**WOKINGHAM
BOROUGH COUNCIL**

Discharge of condition Consultation

Site Address: Land to the West of St Annes Drive and South of London Road, RG40 1PB

Proposal: Application for submission of details to comply with the following condition of planning consent 203544 (APP/X0360/W/22/3297645) dated 20/12/2022. Condition 25 relates to waste and recycling management.

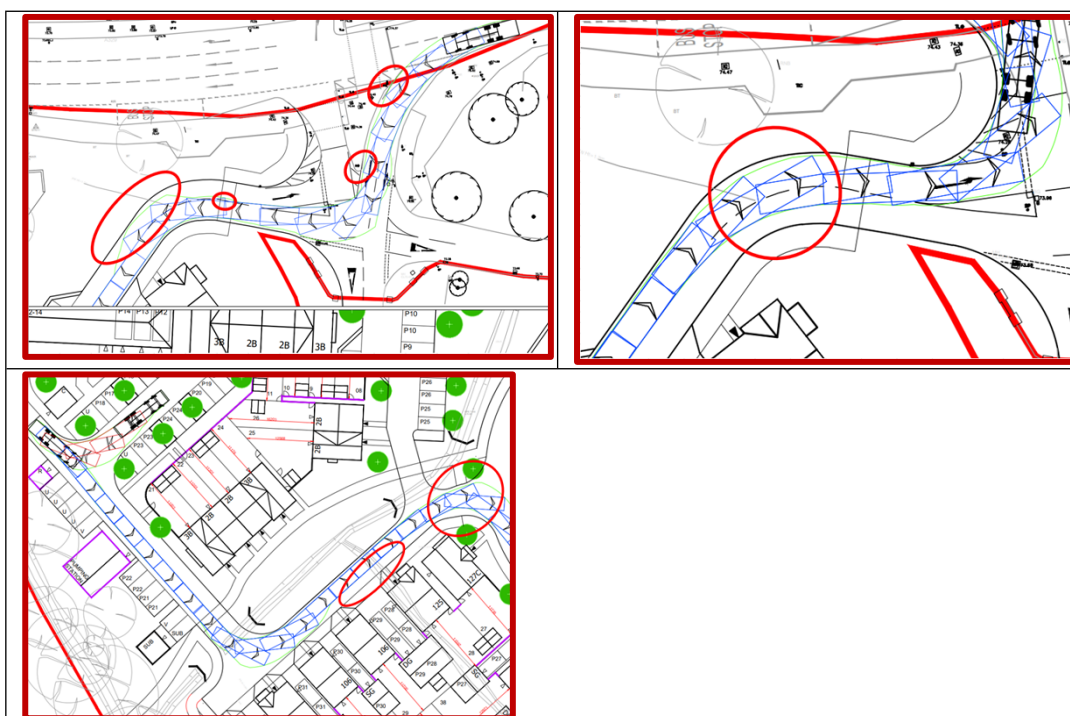
1. The swept paths drawing should be amended to include a scale bar, vehicle specification and vehicle speed used for the tracking. This is to allow the LHA to accurately assess the tracking.

3. The LHA require widening of the bend in the access road. The swept paths show the refuse vehicle overruns the centre line which would present a risk of conflict with vehicles exiting the site or queueing for the traffic lights. The swept paths also show the refuse vehicle is extremely close to the traffic lights and the splitter island and greater passing space is required.

a. Confirmation has been received that the swept paths have been accepted/approved within the Section 38 agreement and therefore the LHA accept the swept paths.
2. The LHA require the applicant to demonstrate a refuse vehicle can pass a standard car on the site access road. This is a standard requirement of developments in Wokingham. Suitable passing space between refuse vehicles and cars is required to minimise the likelihood refuse vehicles or cars will need to reverse to allow the other to pass. Manual for Streets Para 6.8.8 states that: 'Reversing causes a disproportionately large number of moving vehicle accidents in the waste/recycling industry. Injuries to collection
